Station KZSF(AM), San Jose, CA

302-AM Amendment

File Number: BMML-20121005AGW

ENGINEERING STATEMENT:

DERIVATION OF OPERATING PARAMETERS FROM METHOD OF MOMENT MODEL TABLE B

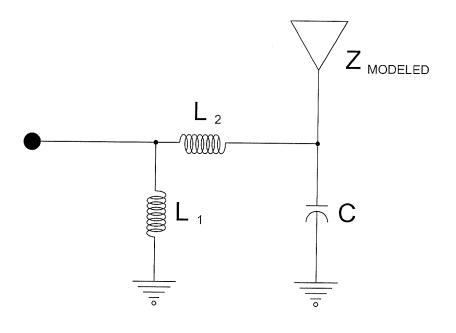
- 1. The antenna monitor ratio for tower #2 must be amended to 0.392 on Page 4 of FCC Form 302-AM, and on the page titled "Derivation of Operating Parameters from Method of Moment Model".
- 2. Item 9 on page 27 must be amended to show that the 4 sampling lines are operating under similar environmental conditions and that the antenna monitor input #3 and #4 were also tested.
- 3. Since the field meter used to take measurements was last calibrated in 1999, a data comparison with a recently calibrated must be provided.
- 4. The harmonic measurement field worksheet on co-located station KSJX(AM) must be provided.

Item 1: Amended pages 4 & 5 of FCC Form 302 and an amended drawing "Derivation of Operating Parameters from Method of Moment Model" are included to correct this round-off or transcription error.

| TOWER | MODEL I MAG | INPUT I MAG | MODEL PHASE | INPUT PHASE | NORMALIZED I MAG PHASE |
|-------|----------------|----------------|----------------|----------------|---------------------------|
| #2 E | 2.3777 | 2.351 | 75.8 | 76.20 | 0.392 / 71.3 |
